Hornsea Project Three
Offshore Wind Farm

Appendix 30 to Deadline I – Permanent Access Note for Onshore HVAC Booster Station

**HORNSEA 3 OFF-SHORE WIND FARM
SAXTHORPE, NORFOLK: BOOSTER STATION
HIGHWAY ACCESS WORKS**

STAGE 1 ROAD SAFETY AUDIT

PROJECT HORNSSEA 3 OFF-SHORE WIND FARM	DATE 26.10.18	DRAWING STATUS INFORMATION	
DRAWING FILE BOOSTER STATION ACCESS JUNCTION	DESIGNED AS SHOWN	DRAWN EC	
CHECKED PZ	APPROVED PZ	1554	create CONSULTING ENGINEERS LTD
CUSTOMER ORSTED	DRAWING No 03/202	REVISION

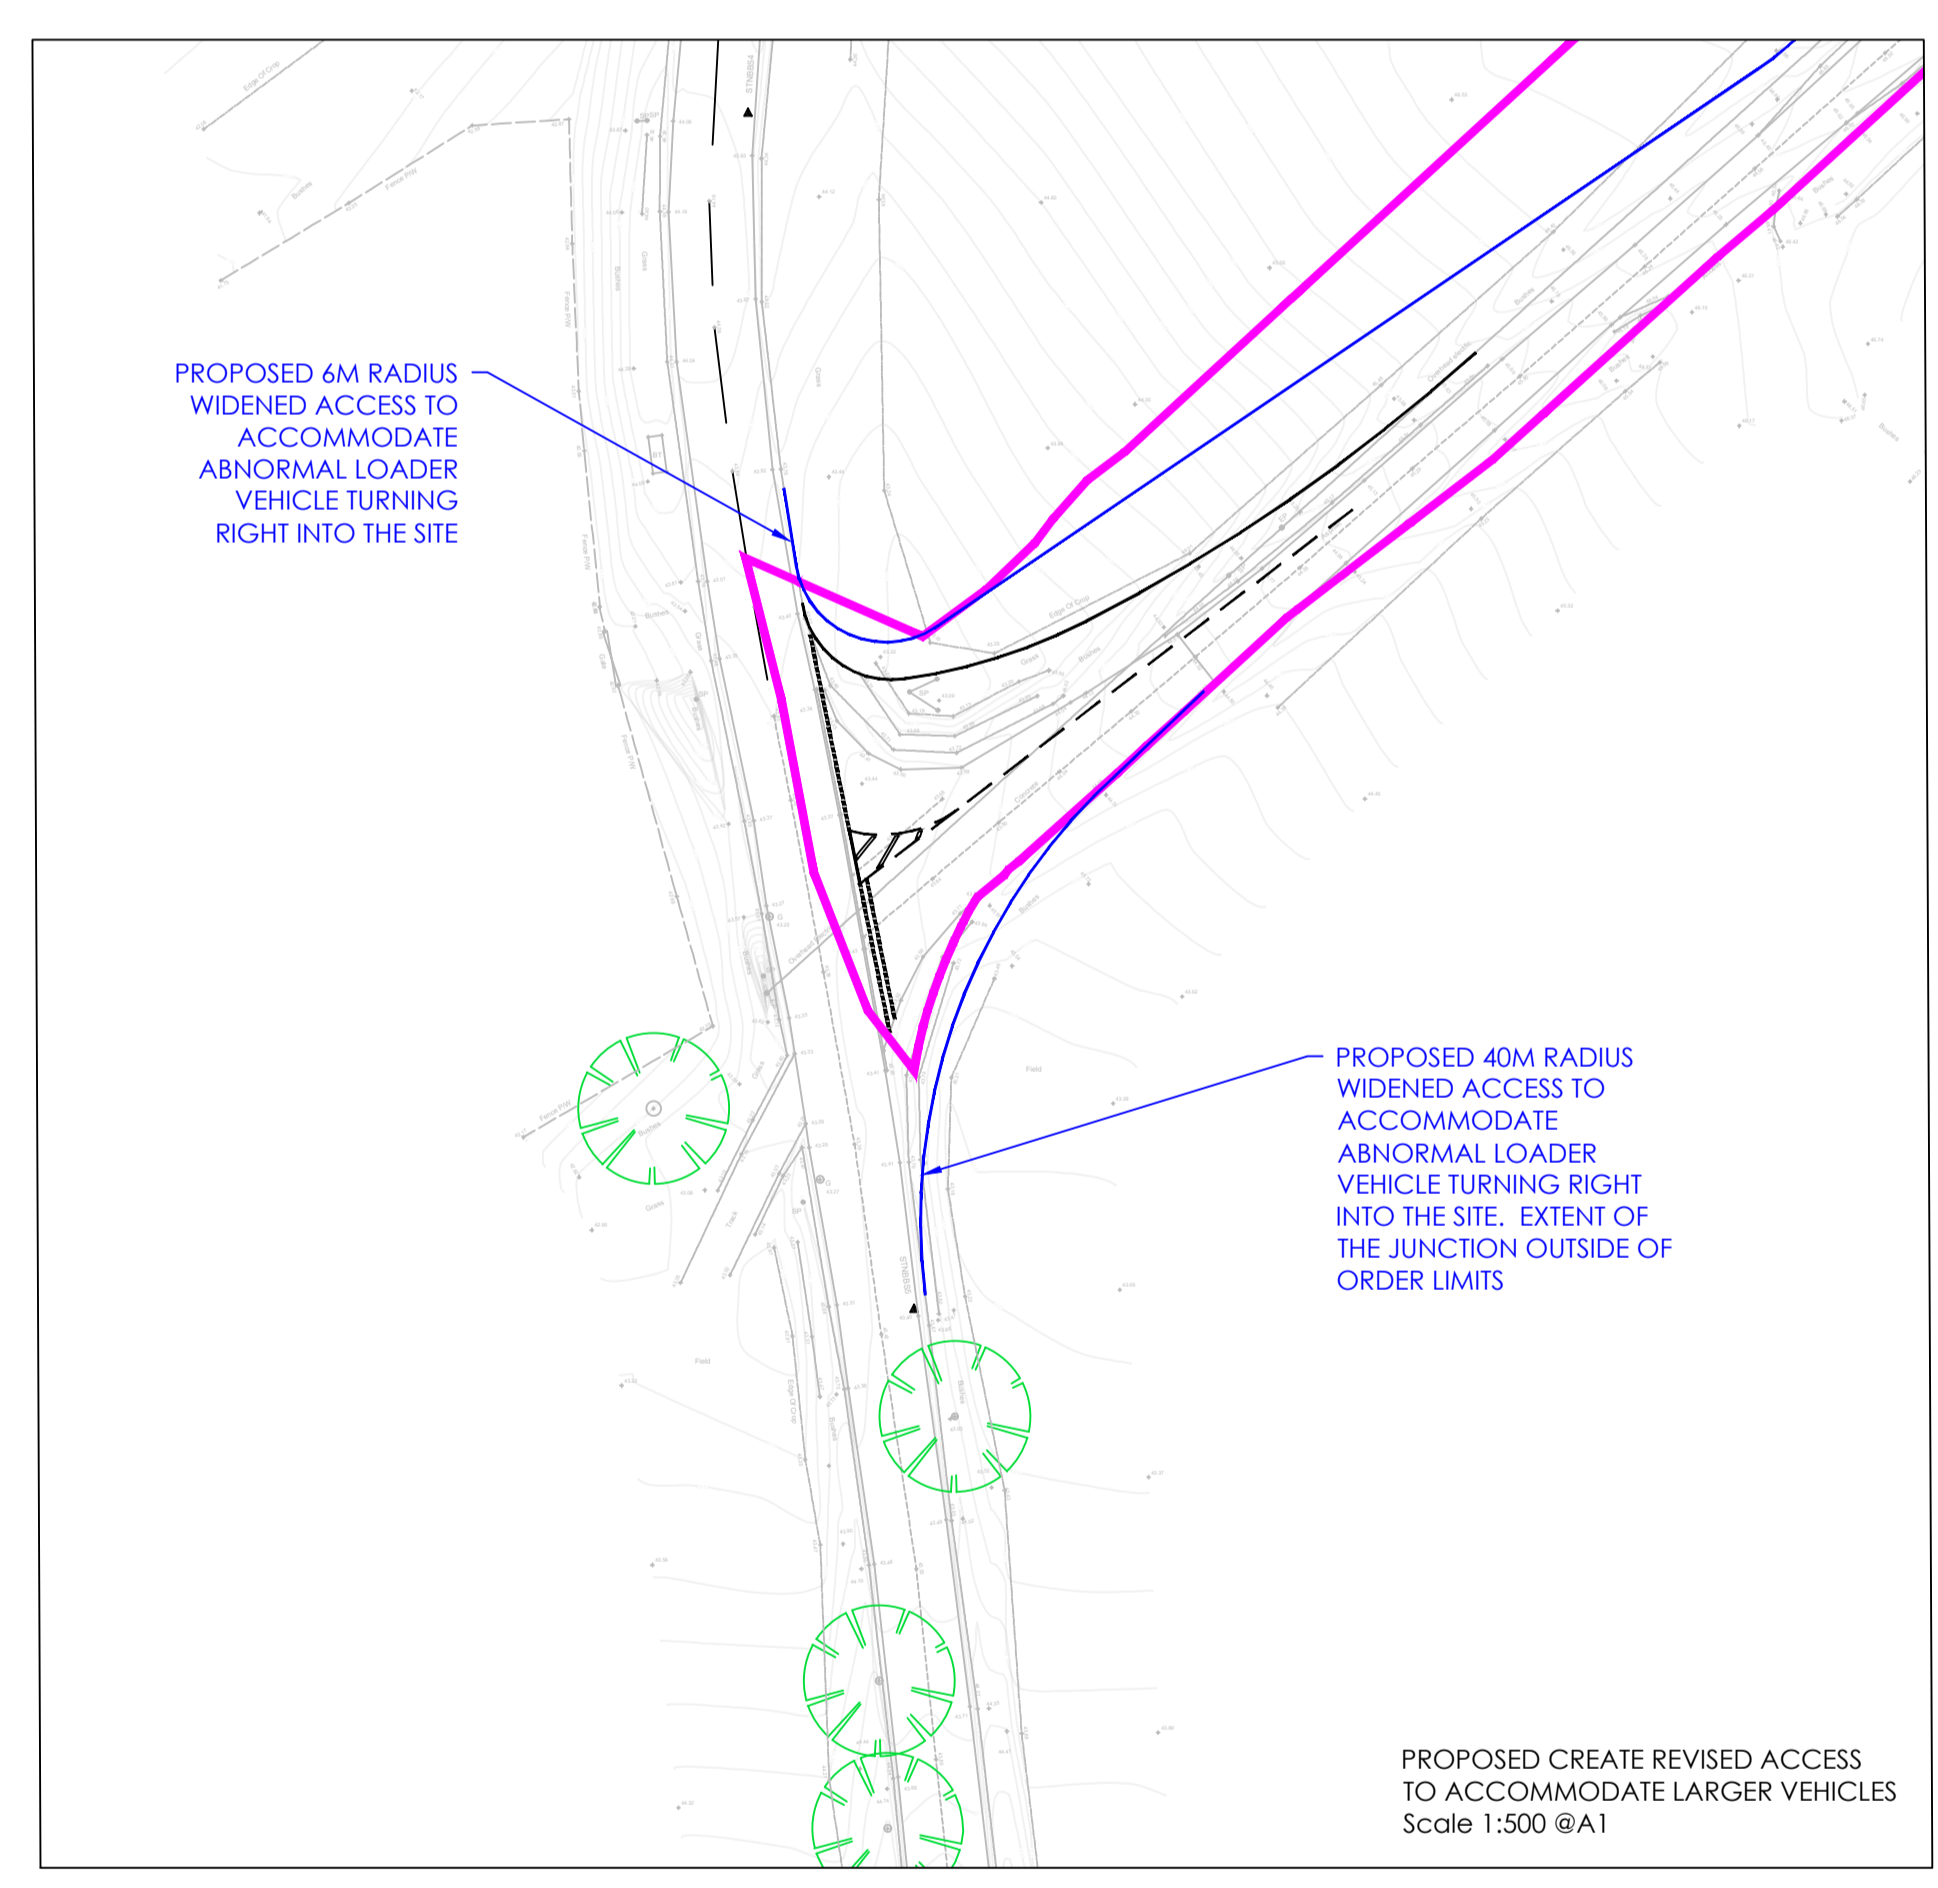
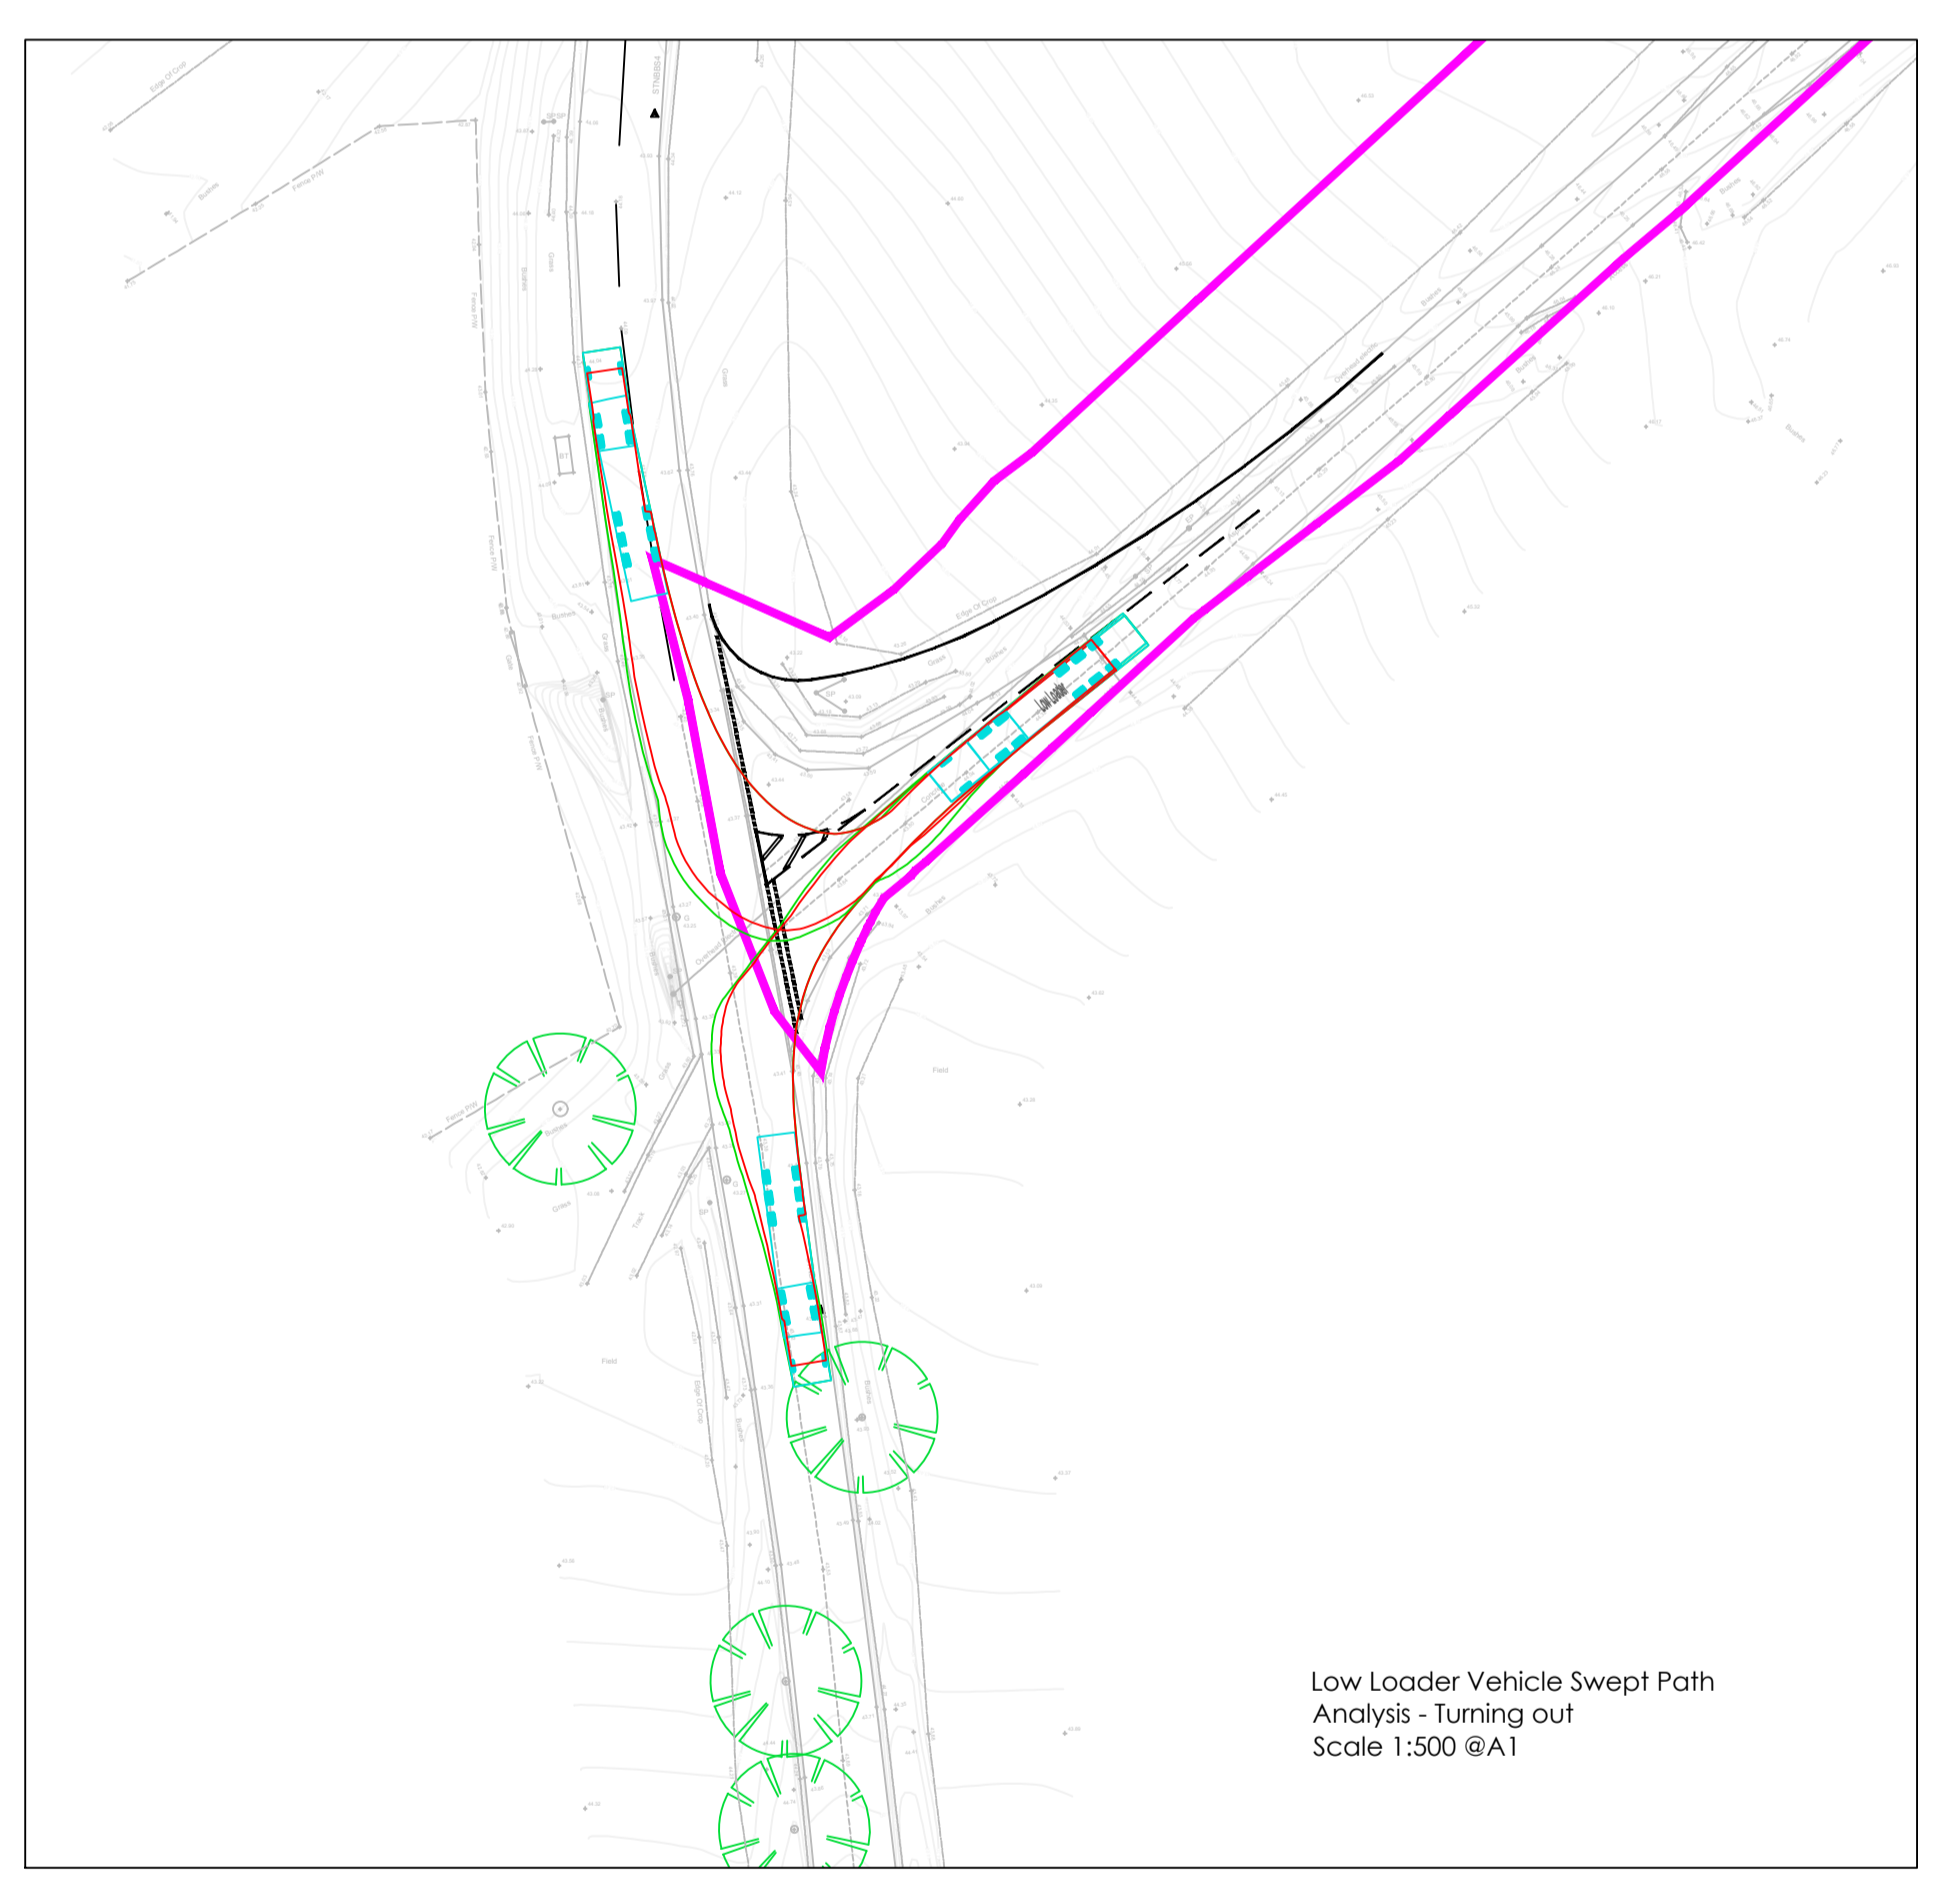
- 4.3 In addition to the above a series of minor alterations have been made to the drawing in response to comments from Norfolk County Council and to reflect property ownership boundaries.
- 4.4 The changes made are shown on Create drawing number 03 / 202 Rev A in Appendix A and include the following;
- Temporary overrun area include which is to be removed post construction, coloured in yellow on the plan;
 - Junction vertical visibility changed in discussion with Norfolk County Council to accommodate a vertical visibility splay of 1.05m to 0.26m; and
 - Temporary overrun area relocated to the north of the current farm track.
